November 24, 2021

Subject: North Shoreview Elementary School HVAC Replacement
San Mateo - Foster City School District
Aedis Project No. 2021005.05
DSA Application #01-119554

ADDENDUM NO. 1

1 PARTIAL FLOOR PLAN - BLDG A - NEW - MECHANICAL & PLUMBING

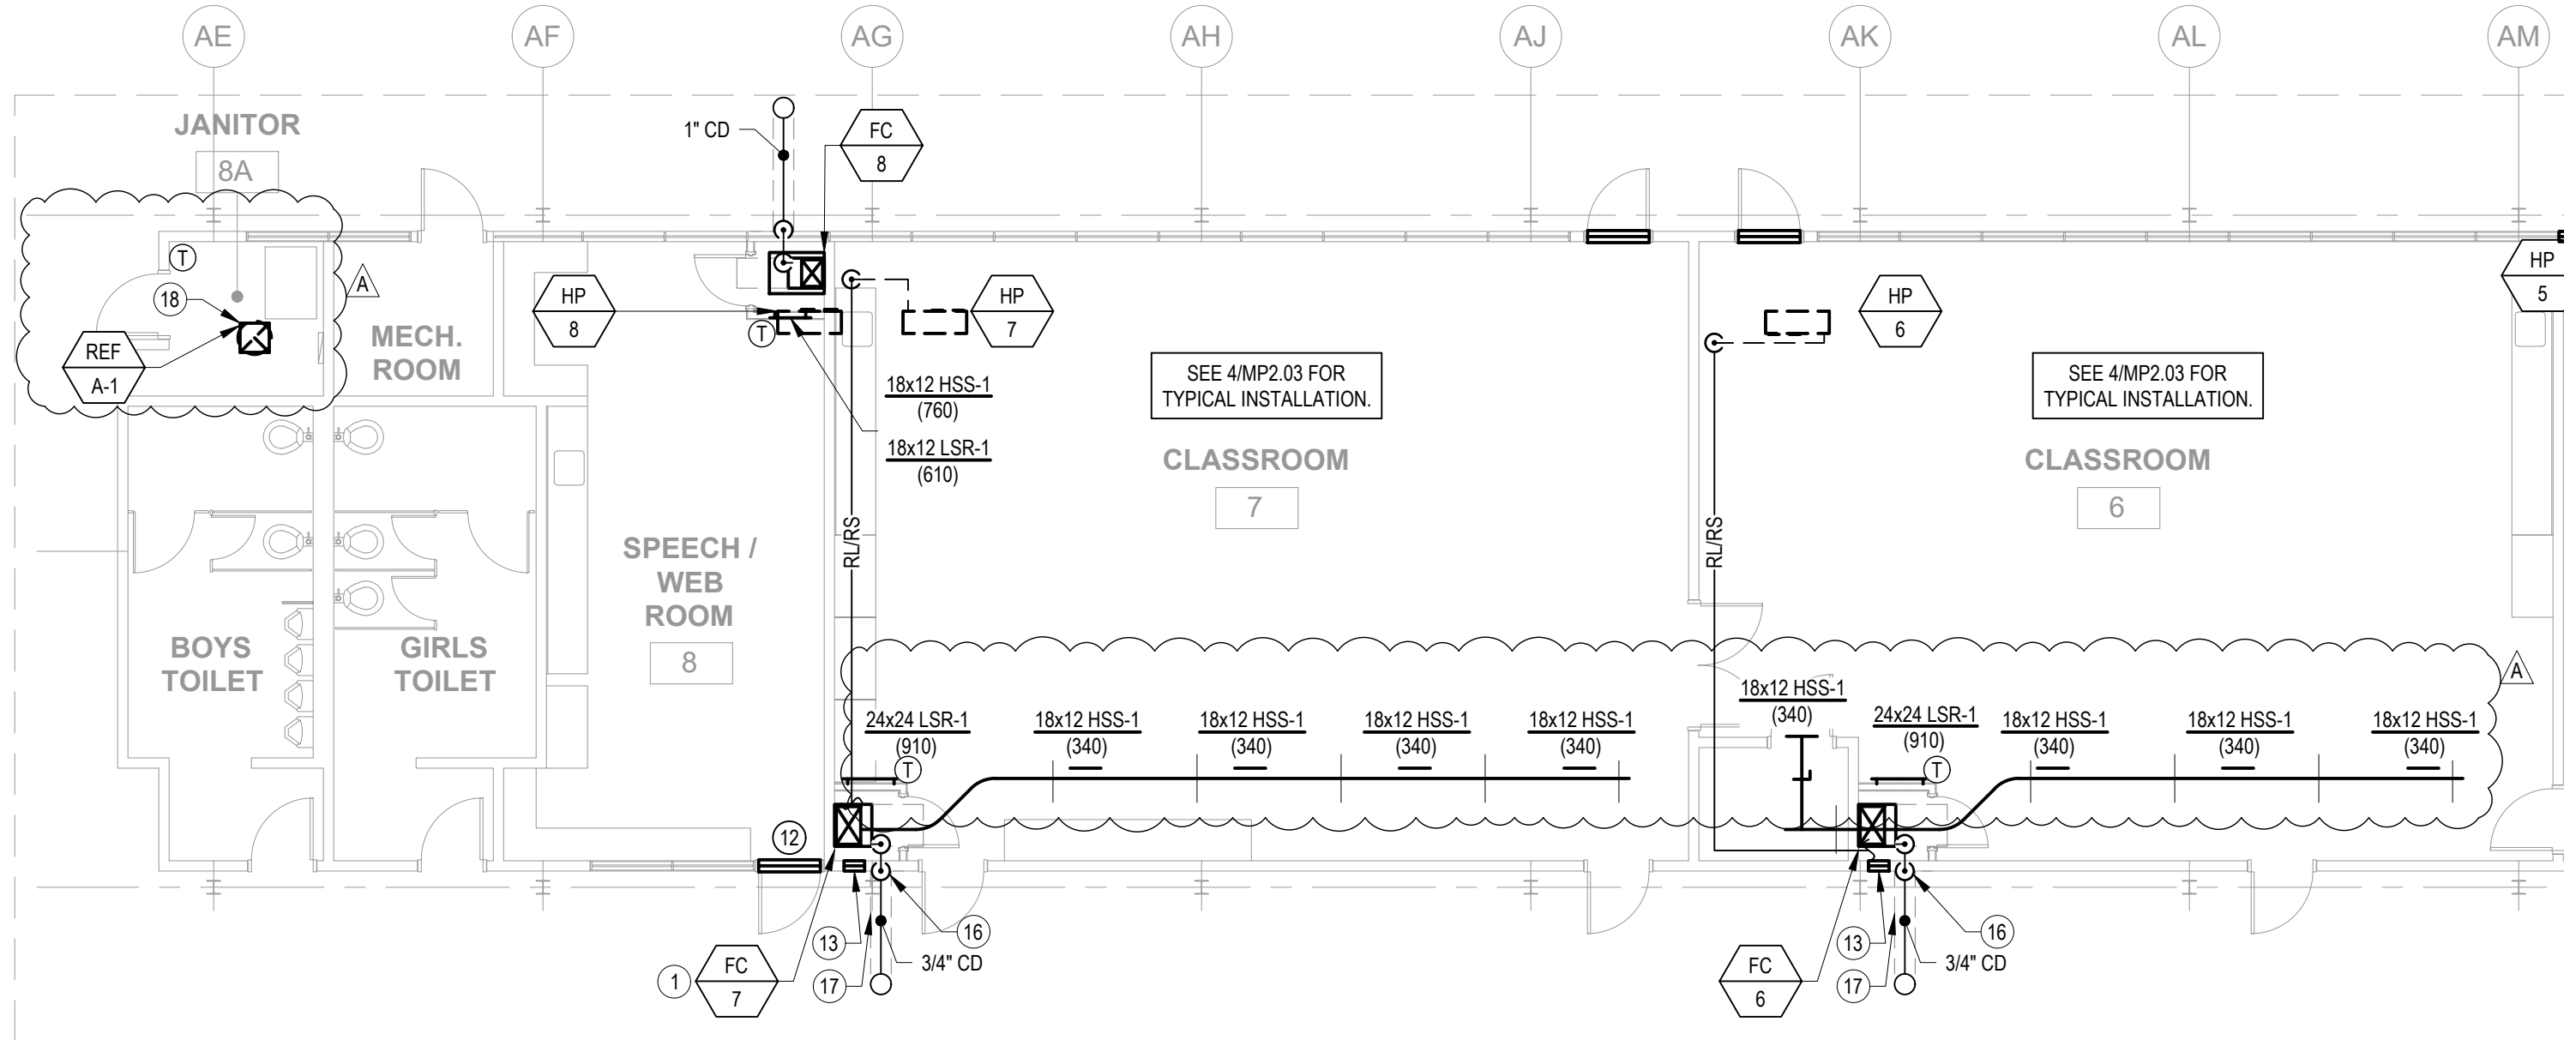
Revise: Revise CFM per AD1-MP2.03a.
Revise: General Notes #4 & #5 AD1-MP2.03a.
Add: New Sheet Note #18 AD1-MP2.03a.
Add: Roof exhaust fan at Janitor 8A per AD1-MP2.03a.
Add: Roof exhaust fan at closet 11A per AD1-MP2.03b.

18. INSTALL EXHAUST FAN ON ROOF.

3 **FLOOR PLAN - ENCLOSURE**
MP2.04 SCALE: NONE

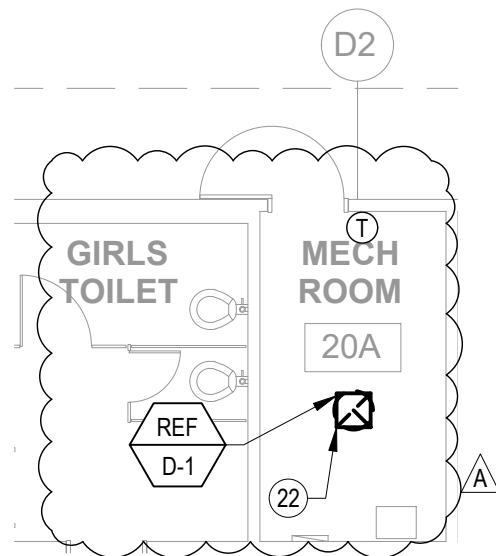
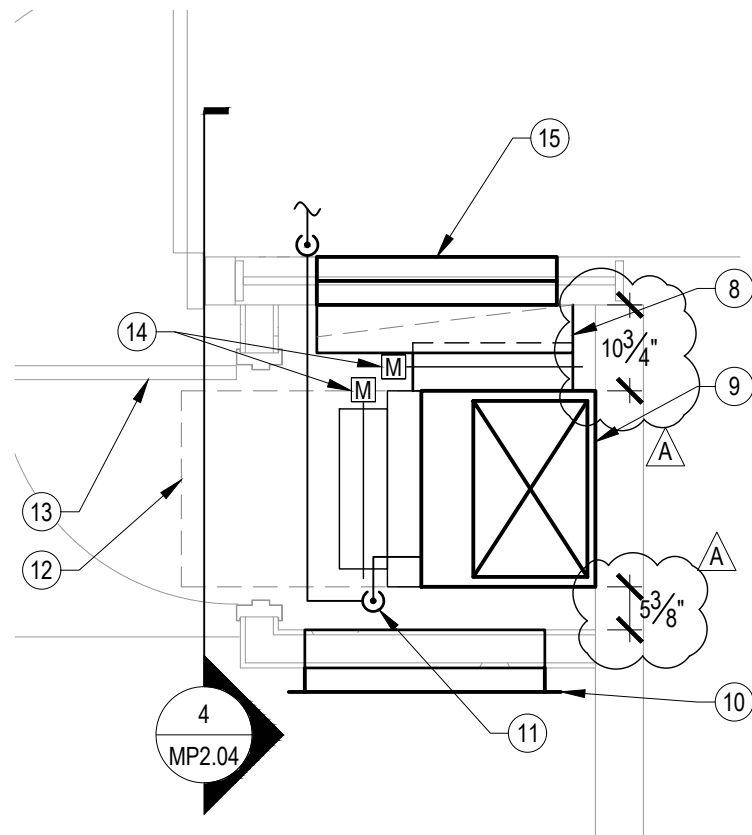
Revise: Revise General #4 & #5 per AD1-MP2.04.
Add: New Sheet Note #22 AD1-MP2.04a.
Add: Dimensions added per AD1-MP2.04a
Add: Roof exhaust fan at Mech Room 20A per AD1-MP2.04a
Add: Roof exhaust fan at Table storage per AD1-MP2.04b

15 EXHAUST FAN MOUNTING

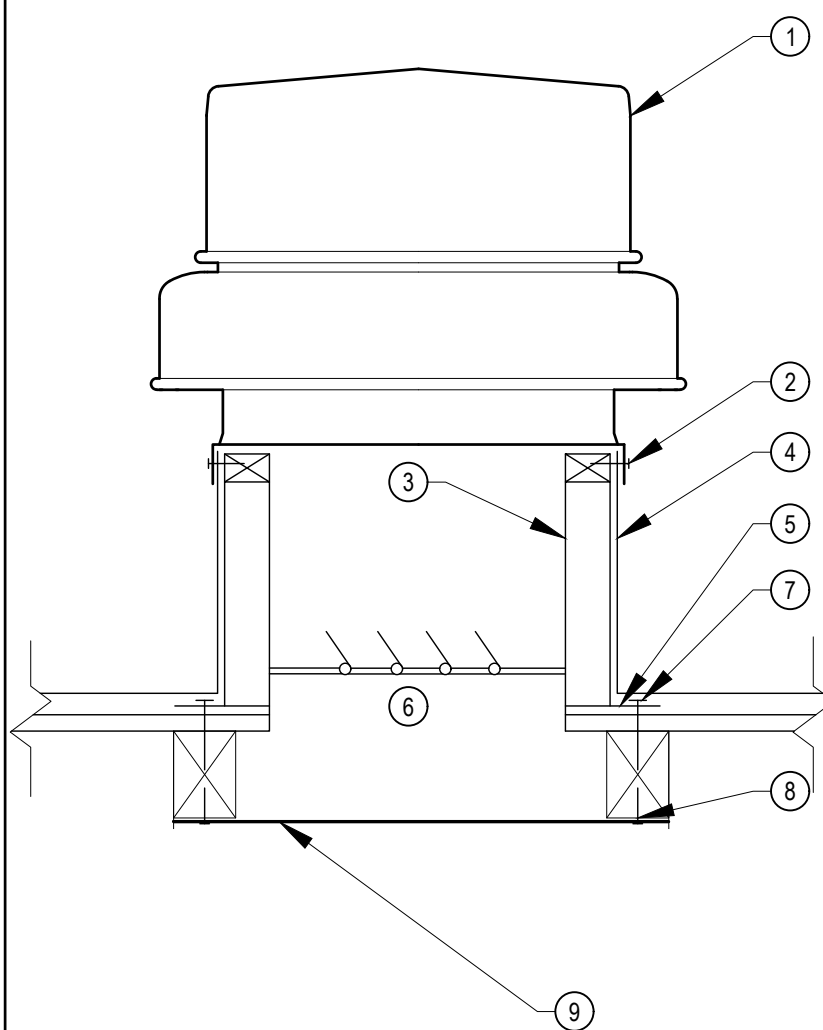
Revise: Detail 4/MP6.01 per AD1-MP6.01.
Add: Detail 15/MP6.01 per AD1-MP6.01

- DETAIL NOTES:
1. EXHAUST FAN.
 2. SECURE TO ROOF CURB WITH #12 SELF TAPPING SCREWS AT 12" ON CENTER. MINIMUM 2 PER SIDE.
 3. FACTORY CURB WITH NAILER.
 4. FOR ROOFING AND FLASHING, SEE ARCHITECT'S DRAWINGS.
 5. ROOF DECK.
 6. BACKDRAFT DAMPER.
 7. 3/8"Ø LAG SCREW THRU CURB AND ROOF WITH 3" MINIMUM EMBEDMENT INTO BLOCKING.
 8. 4x BLOCKING. SECURE TO STRUCTURE WITH SIMPSON HU44 HANGERS EACH END.
 9. 1/4" METAL MESH SCREEN, ATTACHED TO FRAMED BLOCKING W/ #8 WOOD SCREWS @ 6" O.C. ALL AROUND.

DATE 11/24/2021
JOB # 2021005.05
SHEET # AD-1
E1.1

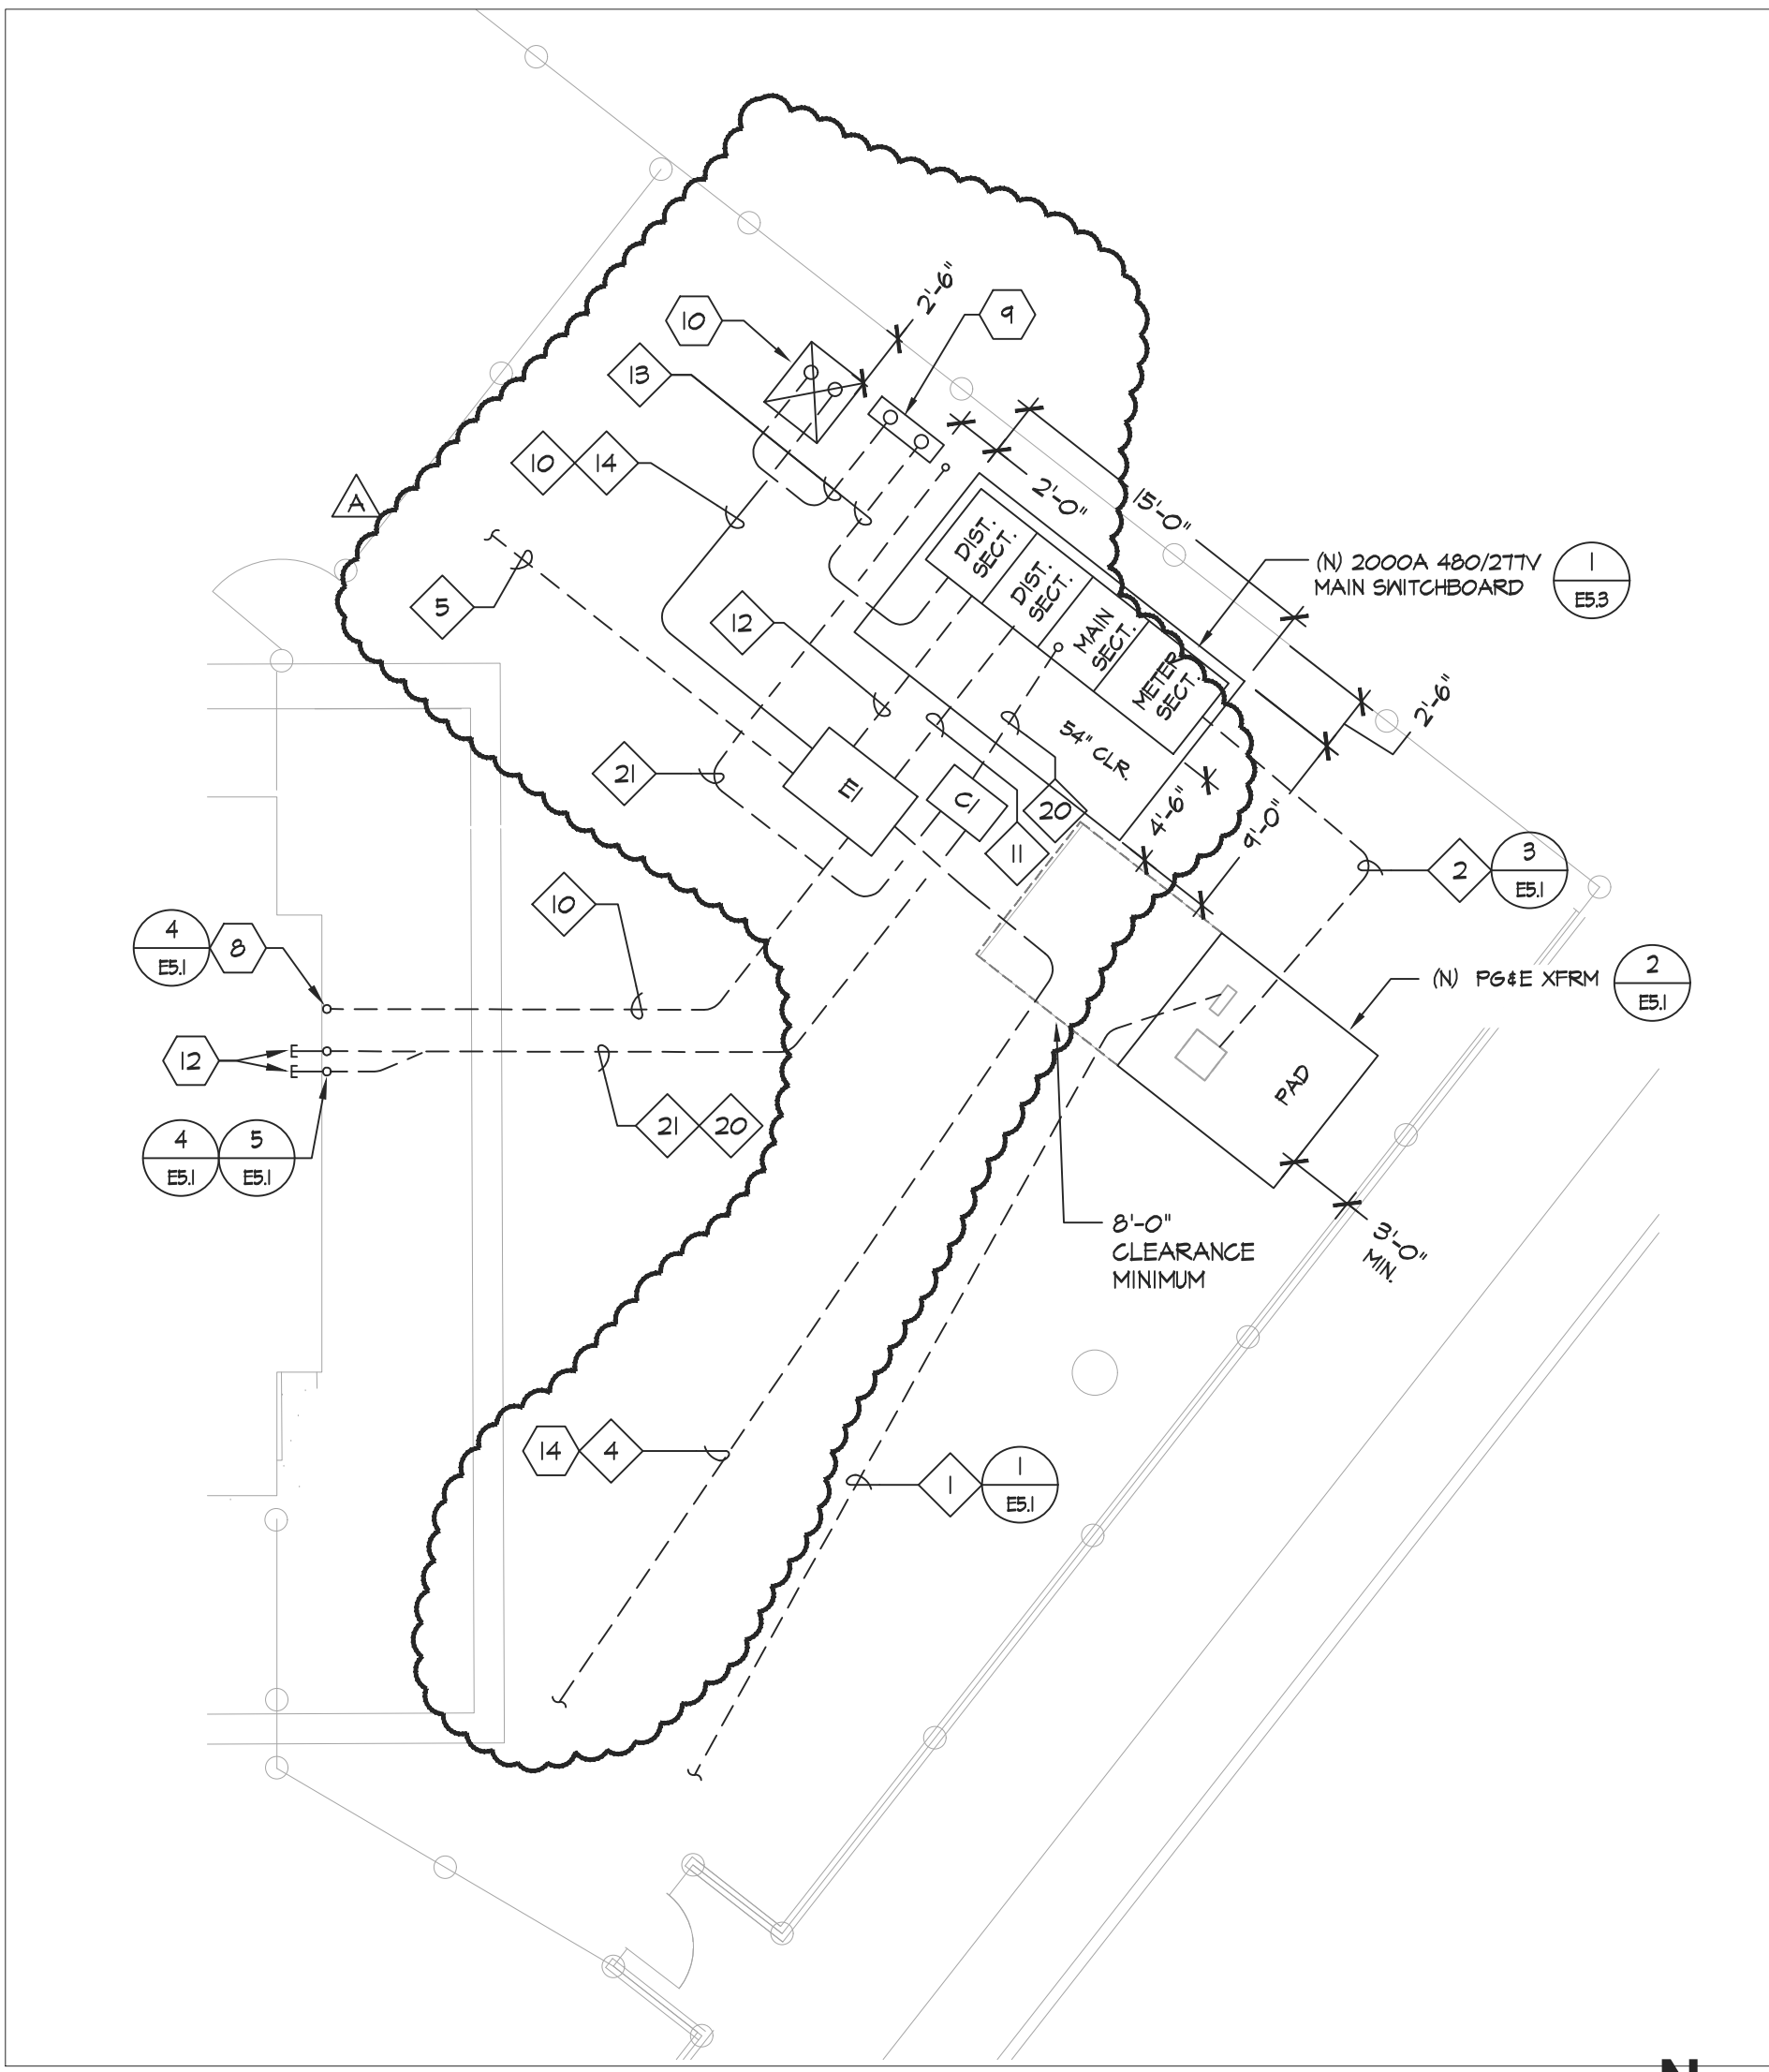
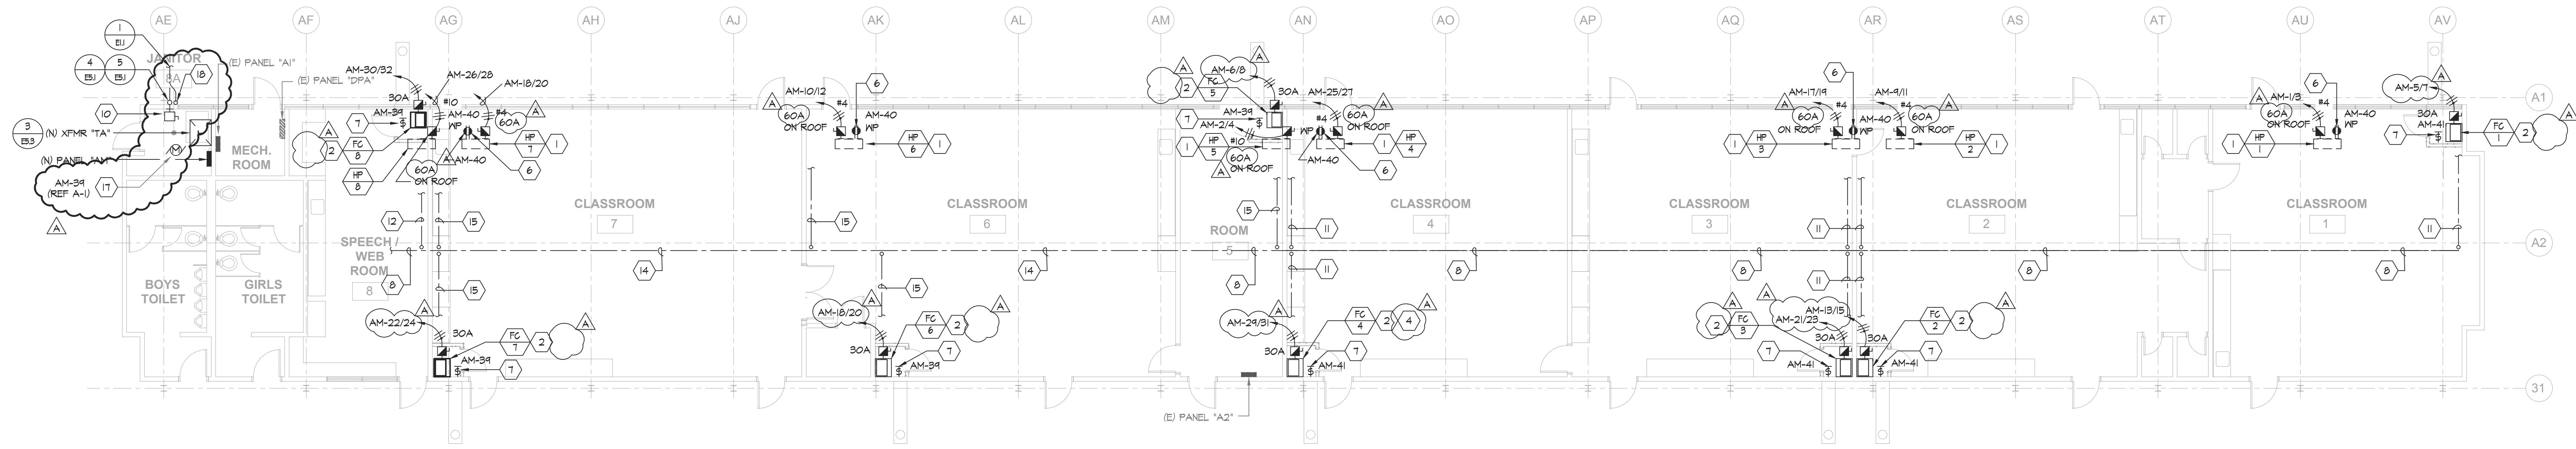
Revise: Conduit Tag #4, #5, #6, #11, #12, #13, #14, #15, #16 and #17 per AD1- E1.1.
Revise: The layout of the site plan per AD1-E1.1.
Revise: Electrical Switchgear Dimensions 2/E1.1 per AD1-E1.1.
Add: Sheet Notes #14 and #15 per AD1-E1.1.
